Differential Return Loss for Clause 137 and Matched COM Package Parameters

For Comments #92 and #93

Richard Mellitz, Samtec

March 2017 IEEE802.3 Plenary, Vancouver, BC, Canada

OPTION B: Do nothing and keep what is in D1.2

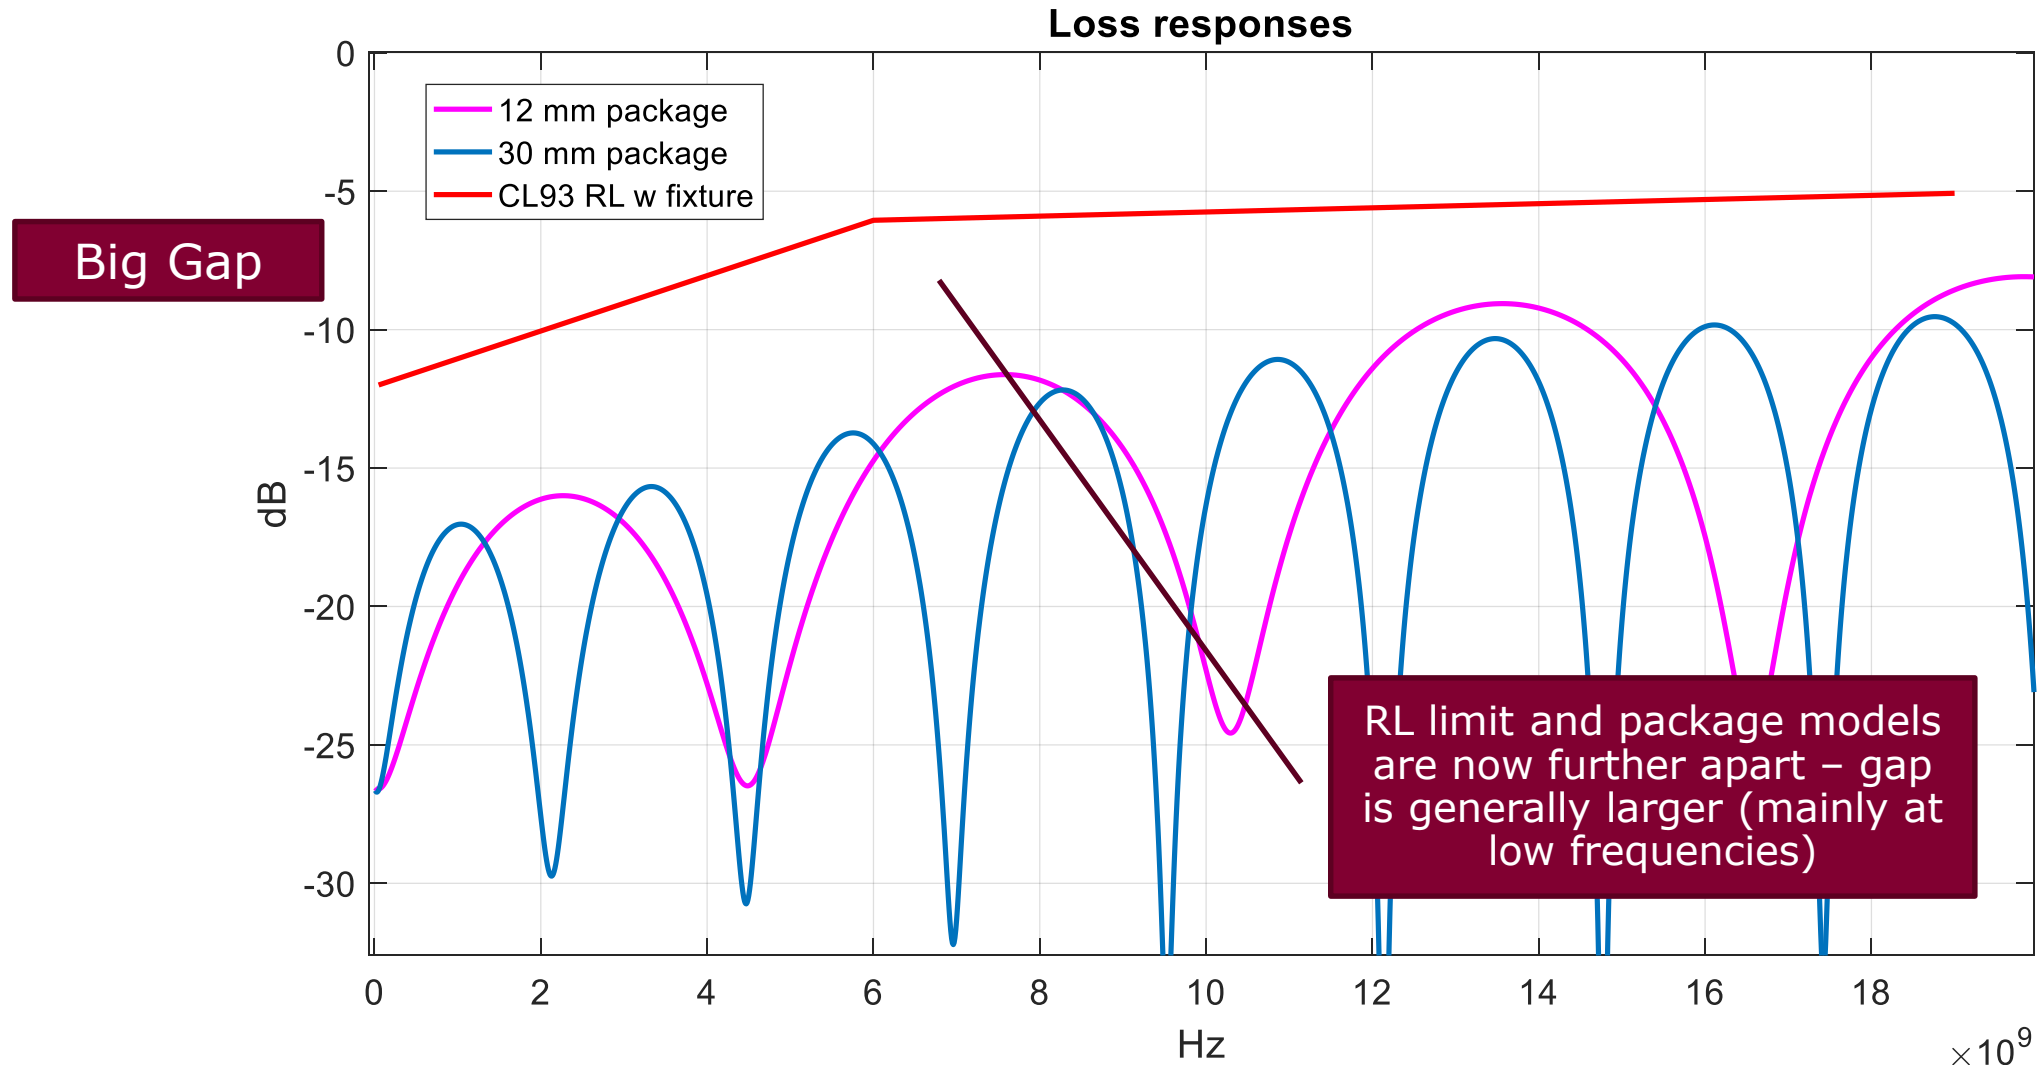
COM package return loss compared to RL limit

OPTION C D1.2 packages and lower RL to match package COM package return loss compared to RL limit

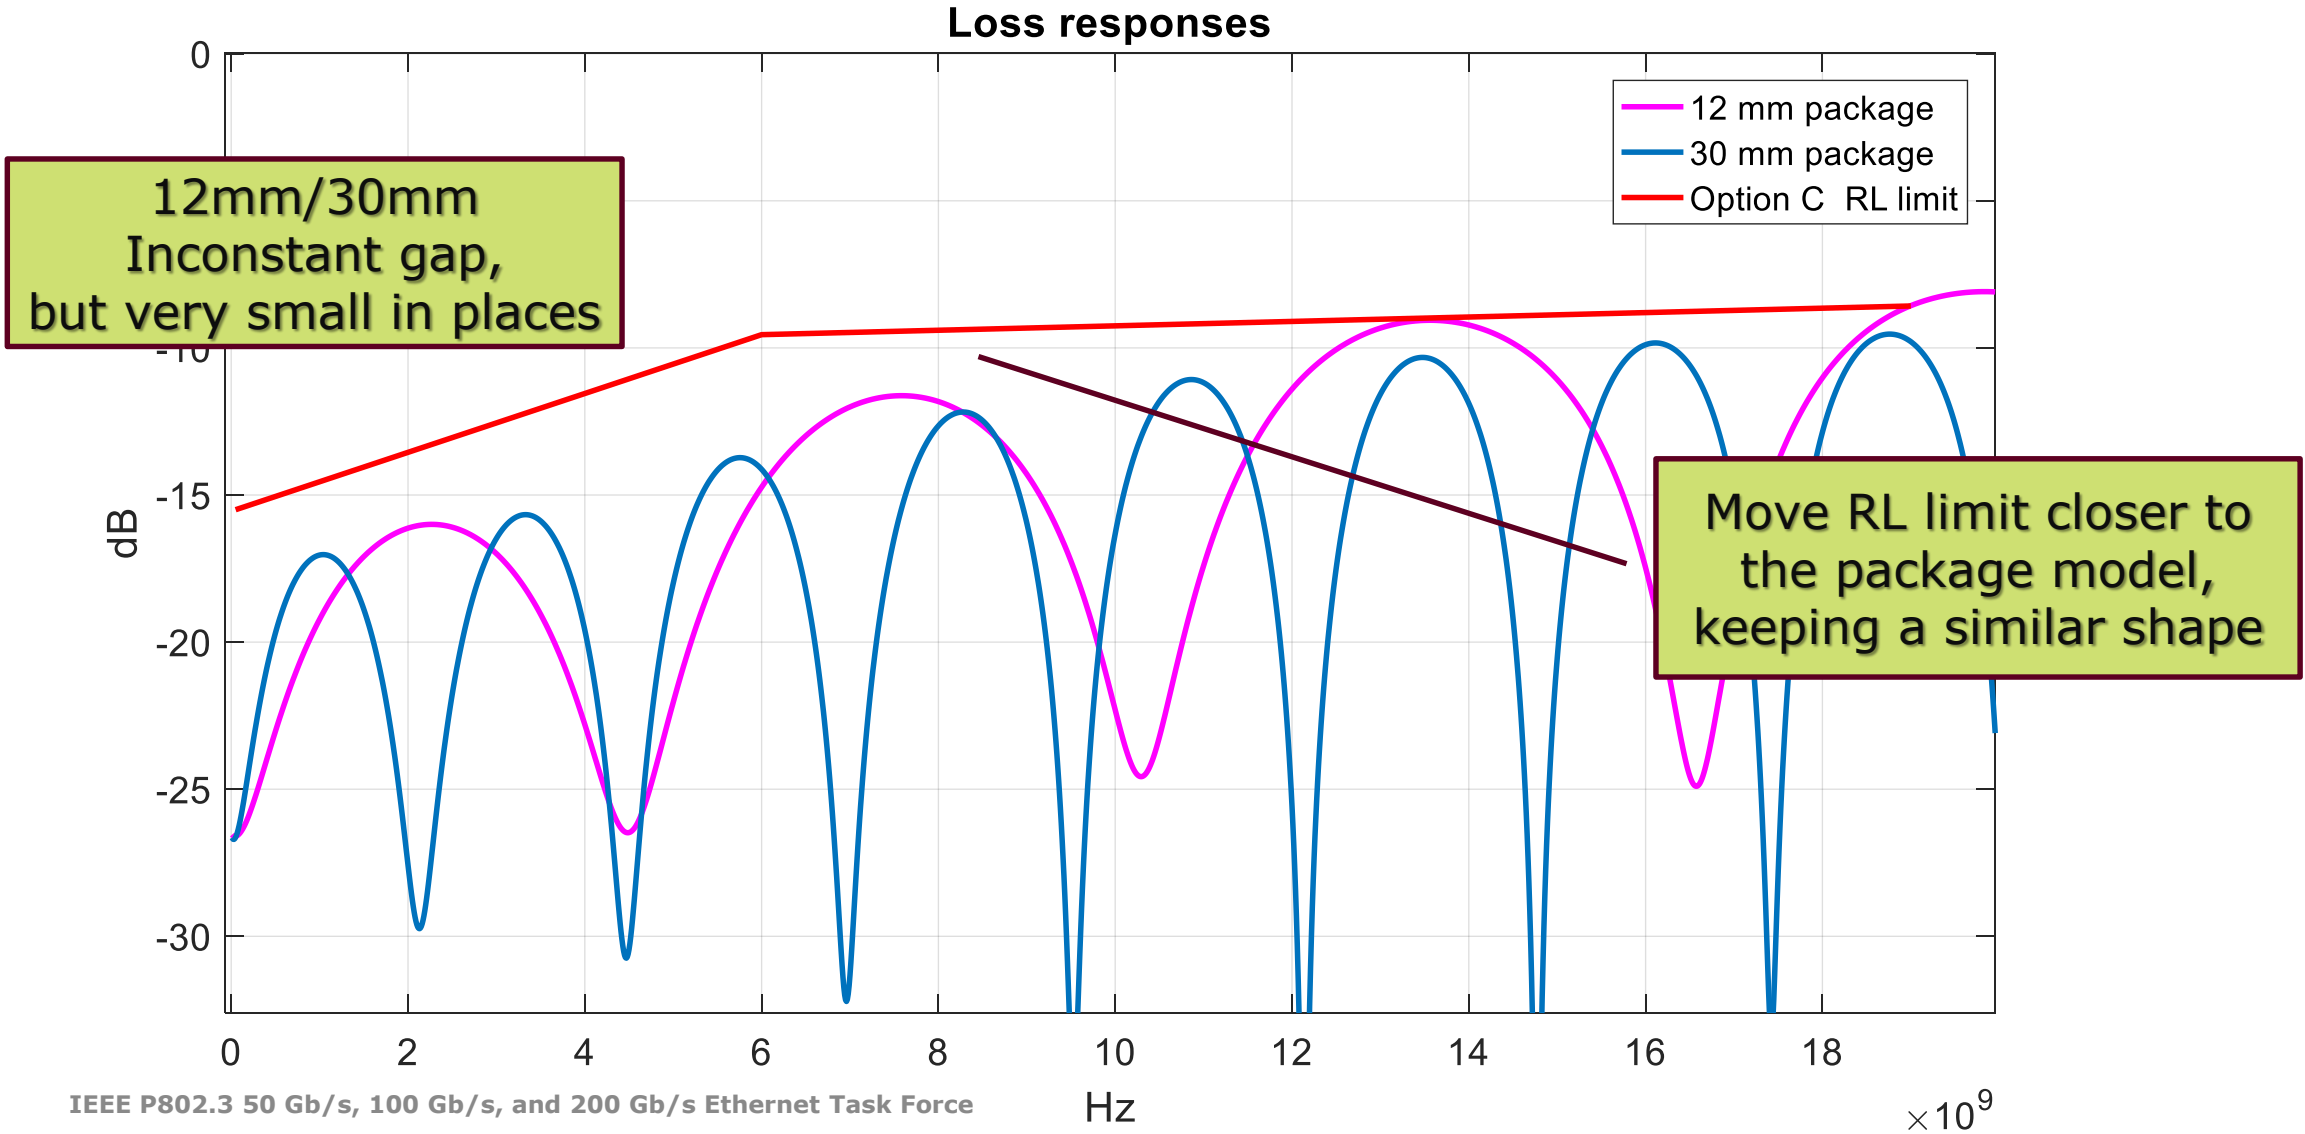
OPTION C: keep packages in D1.2 and lower return loss by 3.5 dB to match package

$$RL_d(f) \geq \left\{ \begin{array}{ll} \overset{15.55}{\cancel{12.05}} - f & 0.05 \leq f \leq 6 \\ \overset{10}{\cancel{6.5}} - 0.075f & 6 < f \leq 19 \end{array} \right\} \text{ dB}$$

Option D: Pedantic COM package for Option C Return Loss

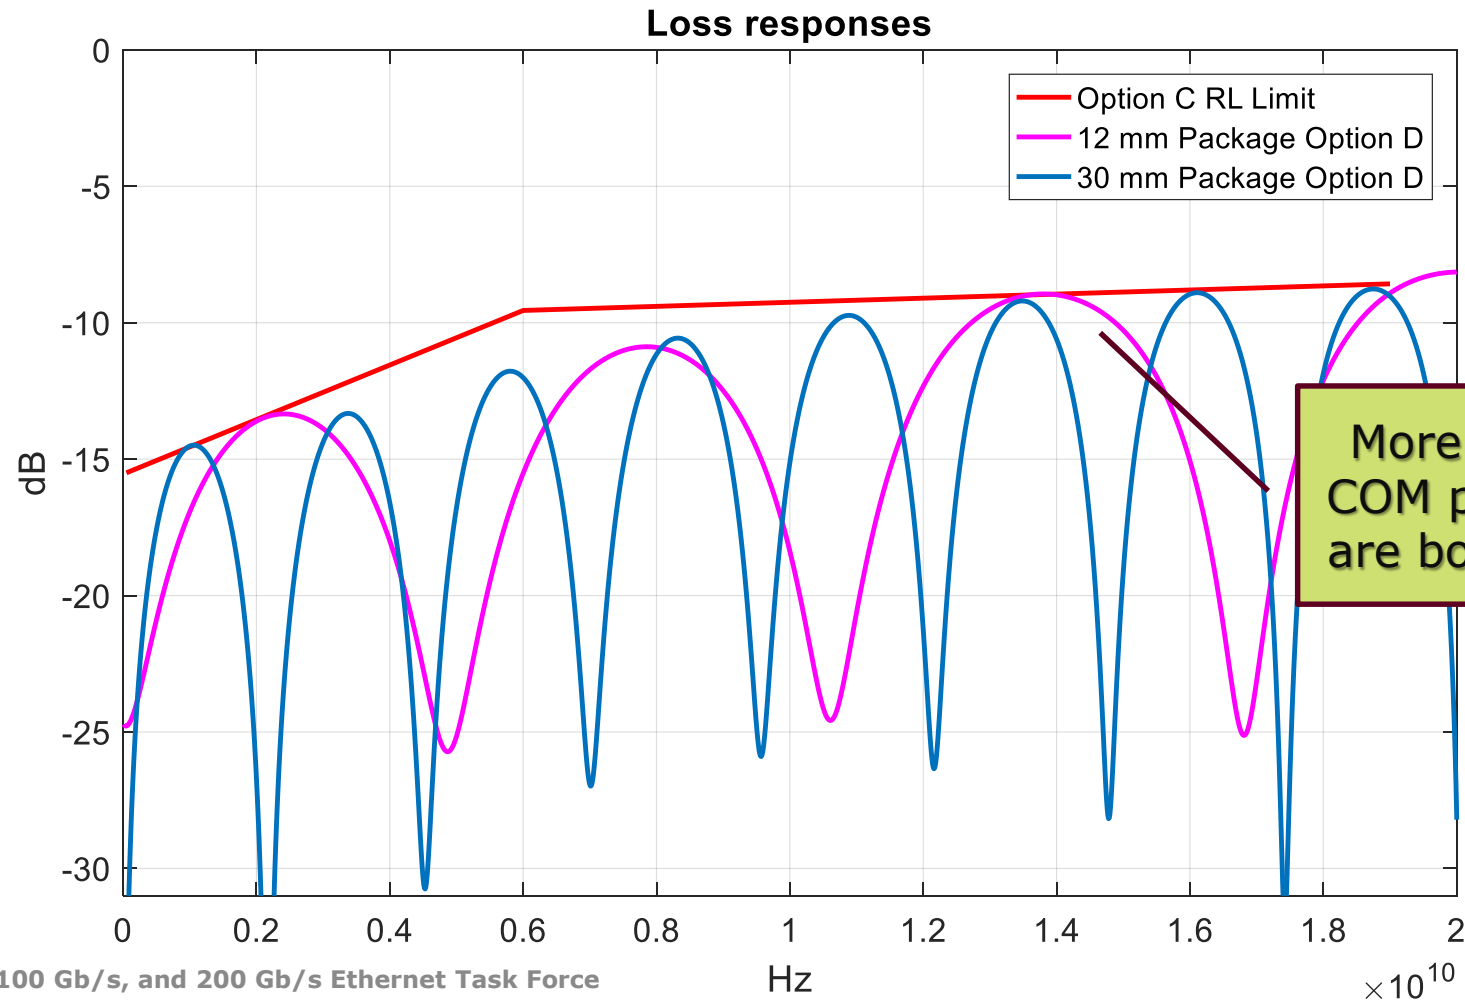
Option D: Pedantic COM parameters for Option C Return Loss

Device package model			
Single-ended device capacitance Test 1	C_d	1.78×10^{-4}	nF
Single-ended device capacitance Test 2	C_d	2.7×10^{-4}	nF
Transmission line length, Test 1	Z_p	12	mm
Transmission line length, Test 2	Z_p	30	mm
Single-ended package capacitance at package-to-board interface	C_p	1.1×10^{-4}	nF
Package transmission line characteristic impedance Test 1	Z_c	84.5	Ω
Package transmission line characteristic impedance Test 2	Z_c	82	Ω

Single-ended termination resistance Test 1	R_d	45	Ω
Single-ended termination resistance Test 2	R_d	50.5	Ω

OPTION E D1.2 packages and lower RL to match package test fixture margin

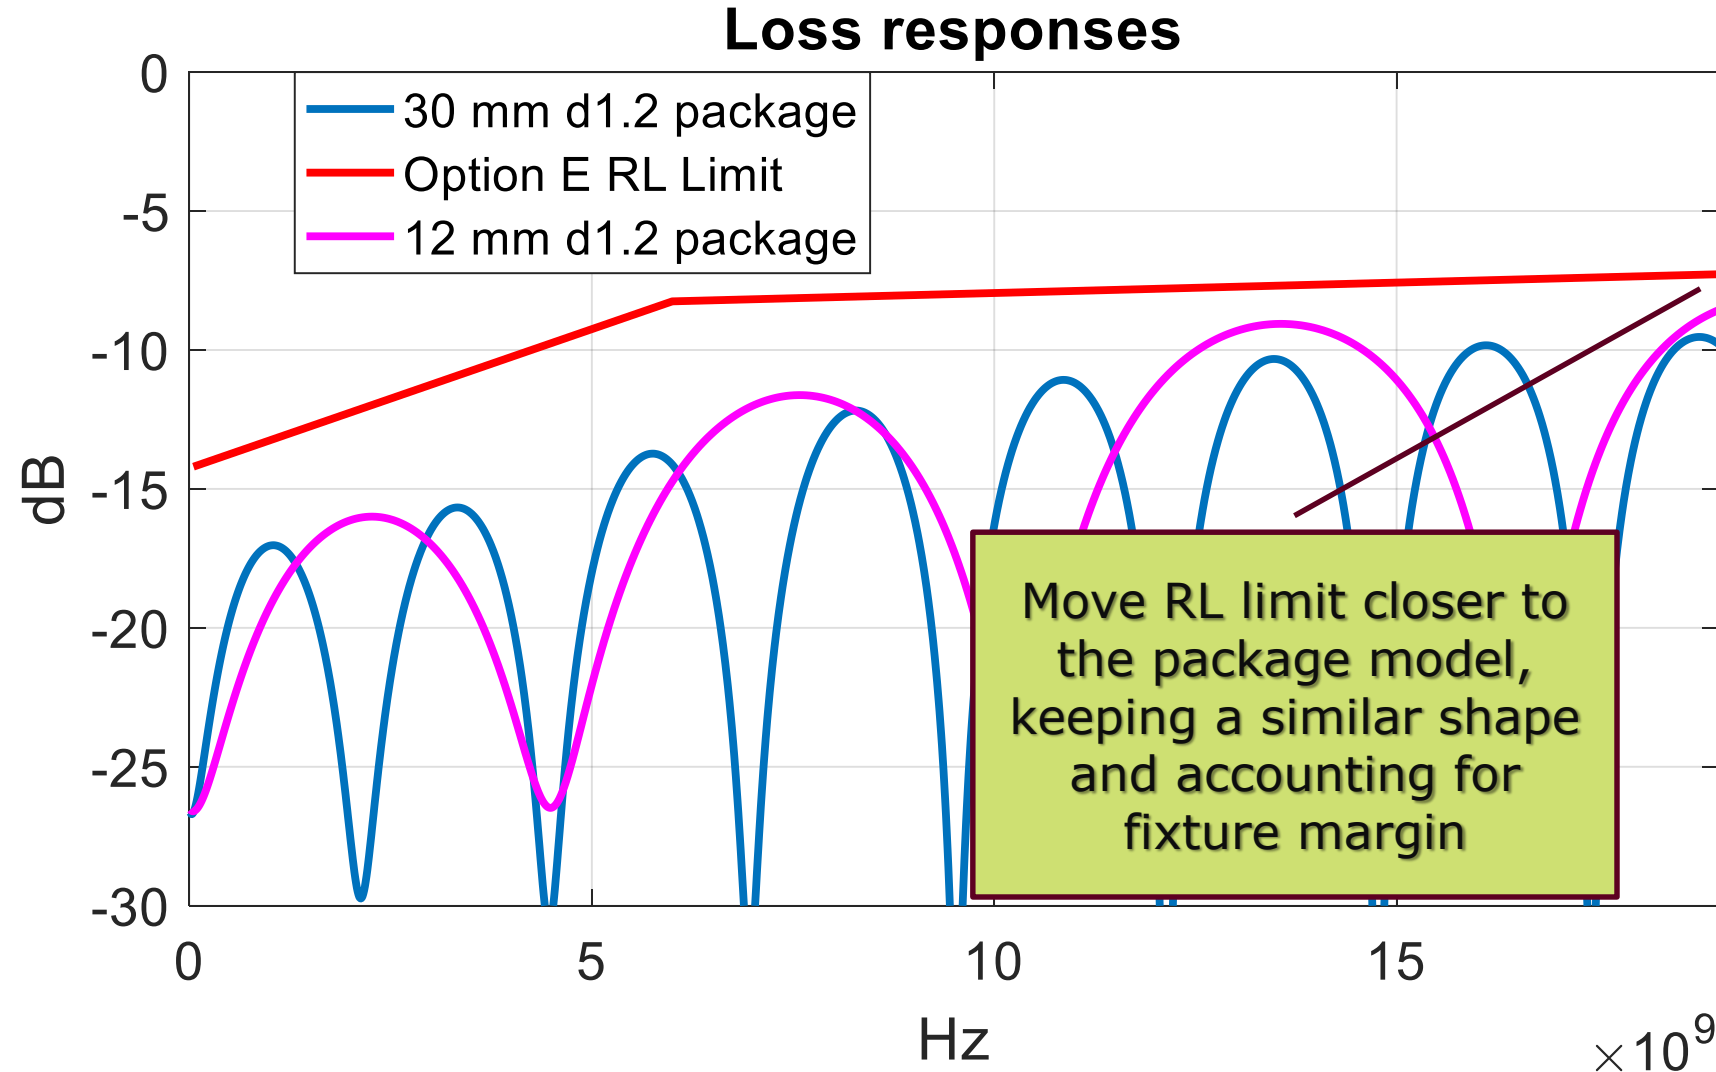
OPTION E: keep packages in D1.2 and lower return loss by 2.2 dB to match package

$$RL_d(f) \geq \left\{ \begin{array}{ll} \overset{14.25}{\cancel{12.05}} - f & 0.05 \leq f \leq 6 \\ \underset{8.7}{\cancel{6.5}} - 0.075f & 6 < f \leq 19 \end{array} \right\} \text{ dB}$$
